NRC DOCKET NUMBERS 50-424 AND 50-425
CONSTRUCTION PERMIT NUMBERS CPPR-108 AND CPPR-109
VOGTLE ELECTRIC GENERATING PLANT - UNITS 1 AND 2
REQUET FOR SUPPLEMENTAL INFORMATION
DSER OPEN ITEM 34 - STEAMLINE BREAK DNBR

RESPONSE TO REQUEST FOR ADDITIONAL INFORMATION
WCAP 9226 (P) 19227 (NP)

QUESTION ON GENERIC STEAMLINE-BREAK TOPICAL REPORT (WCAP-9226)

Figure 14.2-11

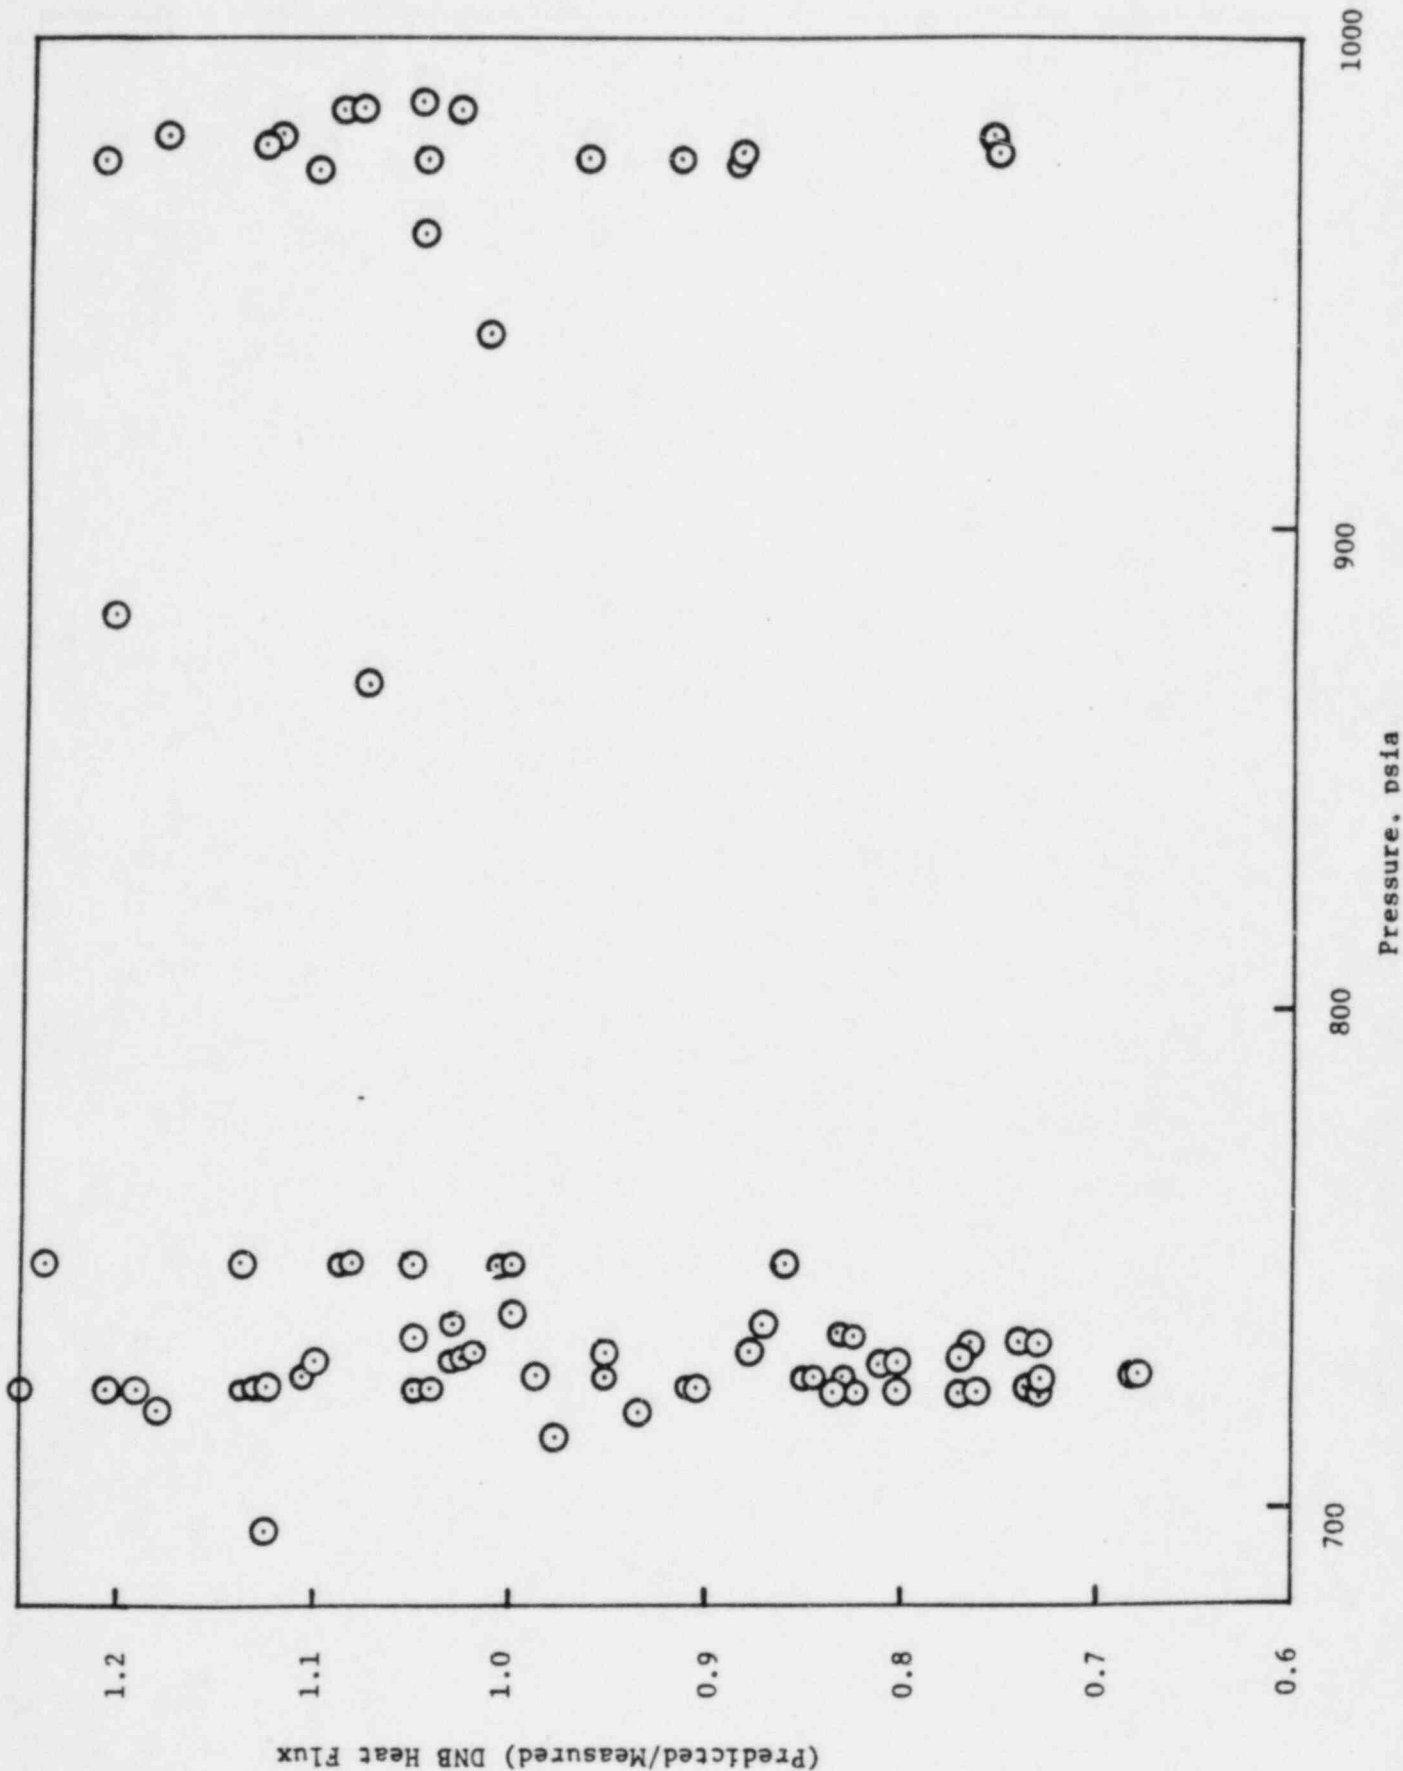
We have reviewed those references and find them incomplete for the range of coolant parameters calculated in WCAP-9226. The references limit the applicability of the W-3 correlation down to 1000 psia. Steamline break analyses, calculated by Westinghouse, have shown decrease in primary system pressure to the range of 500 psia. Provide additional justification for the applicability of the W-3 correlation below 1000 psia. What is the minimum pressure for which the W-3 correlation and corresponding 1.3 minimum DNBR limit can be used?

Reference 2 contains the results of an analysis of low pressure (700 - 1000 psia) data using the W-3 correlation. Those data were taken from the same sources as those used in the development of the W-3 correlation. As shown in the attached figure (taken from Reference 2), no anomalous behavior is observed for the low pressure data.
